Pre-Application Conference

Subject: Memory Care facility

Location: 18000/18001 Upper Midhill Drive (Assessor's Map 21E14CA tax lot 200)

File No: PA-13-33

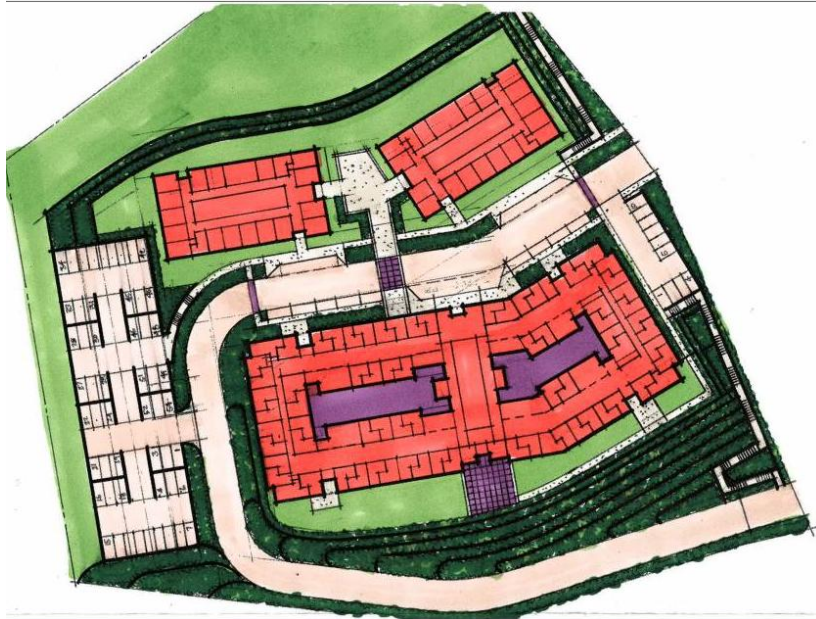
The applicant initially submitted documents showing a single story principal structure between 40,000 and 42,000 square feet in size with 70 units. Two single story cottages were also proposed; each comprising 9,000 to 10,000 square feet and each accommodating 14 to 20 units. Combined, the anticipated number of units would be between 98 and 110. The design was, according to the applicant, a basic template design (see drawing below) which they could subsequently modify as needed.

At the pre-application conference the applicant stated that they are considering a split level design for the main building which would work with the cross slope to result in a smaller footprint and thus preserve more trees at the site.
